## **SMITH'S HIGHLANDS SUBDIVISION, BLOCK 2,** **RESUBDIVISION OF LOTS 1 & 2**

Engineering Comments: FINAL PLAT COMMENTS (should be addressed prior to submitting the FINAL PLAT for review and/or signature by the City Engineer):

***Revised for the August 17, 2017 meeting***

# DETAIL SITE PLAN

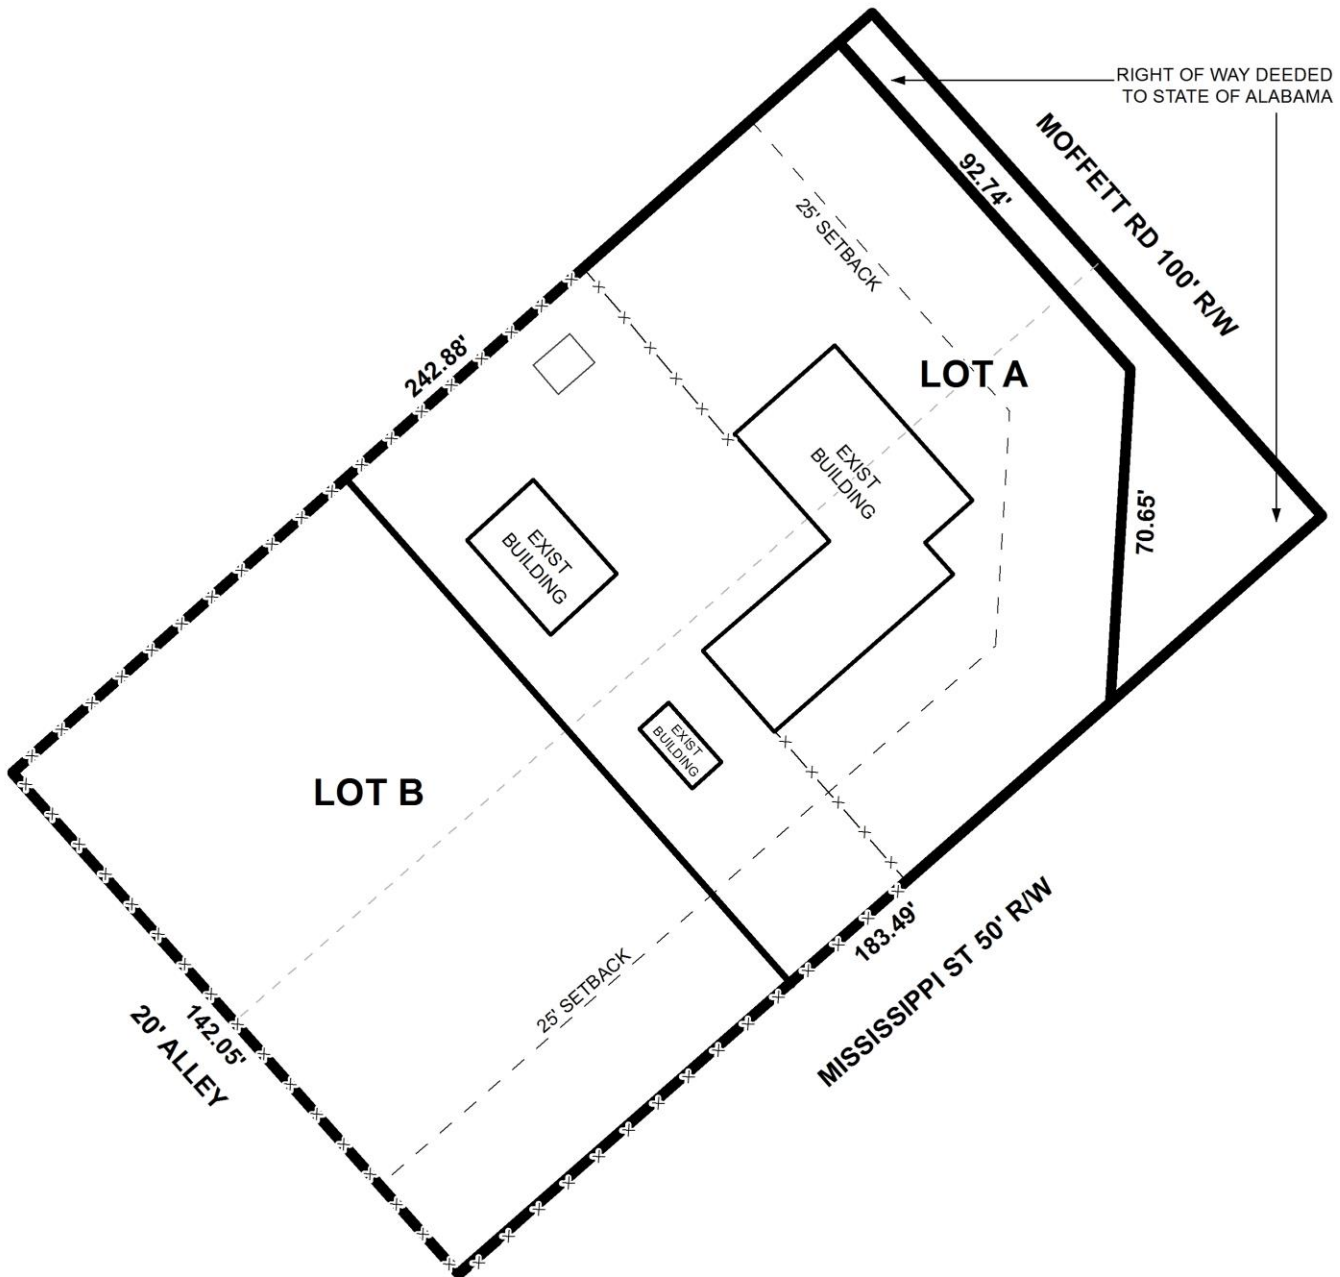
As previously stated, the applicant desires to relocate the interior lot line between the proposed lots A and B. The existing dwelling will be located solely on the proposed Lot A, and not straddle a property lot line as it does in its current configuration. And, the two existing ancillary shed structures and an existing carport will be sited on the proposed Lot B.

Being that the subject site has frontage along both Moffett Road and Mississippi Street, the applicant must ensure that the property lines at this intersection provide a compliant curb radius. The Final Plat, if approved, should be revised to illustrate a dimensioned curb radius in compliance with Section V.D.6. of the Subdivision Regulations.

The 25-foot minimum building setback line is depicted on the preliminary plat along Moffett Road and Mississippi Street, and as such, should be retained on the Final Plat, if approved.

Both lots exceed the 7,200 square foot minimum lot size requirements for lots served by public water and sanitary sewer systems. The lot size information is indicated in both square feet and in acres and should be retained on the Final Plat, if approved.

It should be noted that the site is commercially-zoned, and while a zero-foot side-yard setback is allowed by the Zoning Ordinance, a 10-foot setback is required when a residential use abuts a commercial use, even within a commercial district. Thus, the proposed subdivision may result in a Zoning Ordinance violation. Furthermore, the subdivision will result in accessory buildings on a lot without a primary structure, which is also a Zoning Ordinance violation.

Finally, the proposed location of the internal lot line will create Building and Fire Code compliance problems, as structures will require fire-rating of walls, soffits, eaves, and roofs due to the setback.

*The latest revision of the preliminary plat places the existing primary residence, ancillary shed structures, and carport solely on the proposed Lot A, with the nearest building structure being setback a distance of 10.5' from the proposed rear property line. The proposed Lot B will consist of vacant land.*

*It was also mentioned at the July 20<sup>th</sup> meeting that due to the the subject site having frontage along both Moffett Road and Mississippi Street, that the intersection must provide a compliant curb radius. While a curb radius was not indicated on the revised plat, an angled right-of-way/lot line is shown. The Final Plat, if approved, should be revised to illustrate a dimensioned curb radius in compliance with Section V.D.6. of the Subdivision Regulations, if required.*

*The 25-foot minimum building setback line is depicted on the revised preliminary plat along Moffett Road and Mississippi Street, and as such, should be retained on the Final Plat, if approved.*

*The proposed position of the interior lot line on the revised site plan reflects compliance with the regulations of the Zoning Ordinance as it relates to setbacks, isolated ancillary structures on a single lot, as well as Building and Fire Code compliance.*

**Subdivision:** *The Subdivision request is recommended for Tentative Approval, subject to the following conditions:*

- 1) Retention of the right-of-way widths along Moffett Road and Mississippi Street;*
- 2) Dedication of a corner radius at the intersection of Moffett Road and Mississippi Street, if determined necessary by the City Engineer;*

- 3) Retention of the 25-foot minimum building setback line from all street frontages;*
- 4) Retention of the lot size information in both square feet and in acres;*

- 5) Placement of a note on the Final Plat stating that both Lots A and B are limited to one curb-cut each to Mississippi Street, with any changes in the size, location and design to be approved by Traffic Engineering and conform to AASHTO standards;*

- 6) Placement of a note on the Final Plat stating that Lot A is denied access to Moffett Road;*
- 7) Compliance with Engineering comments (FINAL PLAT COMMENTS) (should be addressed prior to submitting the FINAL PLAT for review and/or signature by the City Engineer): A. Provide all of the required information on the SUBDIVISION PLAT (i.e. signature blocks, signatures, certification statements, written legal description, required notes, legend, scale, bearings and distances) that is required by the current Alabama State Board of Licensure for Professional Engineers and Land Surveyors. B. Provide and label the monument set or found at each subdivision corner. C. Add a signature block for the Owner, Notary Public, Planning Commission, Traffic Engineer, and City Engineer. D. Provide the Surveyor's Certificate. E. Provide the Surveyor's, Owner's (notarized), Planning Commission, and Traffic Engineering signatures. F. Add a note to the SUBDIVISION PLAT stating that a Land Disturbance permit will be required for any land disturbing activity in accordance with Mobile City Code, Chapter 17, Storm Water Management and Flood Control); the City of Mobile, Alabama Flood Plain Management Plan (1984); and, the Rules For Erosion and Sedimentation Control and Storm Water Runoff Control. G. Add a note to the SUBDIVISION PLAT stating that as shown on the 1984 aerial photo (FLIGHT 21 - #69) the Lot(s) will receive the following historical credit of impervious area towards stormwater detention requirement per Mobile City Code, Chapter 17, Storm Water Management and Flood Control), as follows: LOT A – 2,500 SF; LOT B – 800 SF. The applicant may wish to coordinate with City Engineering Department staff to establish the exact amount prior to the submittal of the Land Disturbance Permit application. H. Add a note to the Plat stating that the approval of all applicable federal, state, and local agencies (including all storm water runoff, wetland and floodplain requirements) will be required prior to the issuance of a Land Disturbance permit. I. Add a note that sidewalk is required to be constructed, and/or repaired, along the frontage of each lot, or parcel, at time of new development or construction, unless a sidewalk waiver is approved. J. Provide a copy of the FINAL SUBDIVISION PLAT to the Engineering Dept. for review. No signatures are required on this drawing. K. After addressing all of the FINAL SUBDIVISION PLAT review comments by the Engineering Dept. provide the ORIGINAL (with all other signatures) and one (1) copy (signatures not required) of the revised Final Plat to the Engineering Department.);*
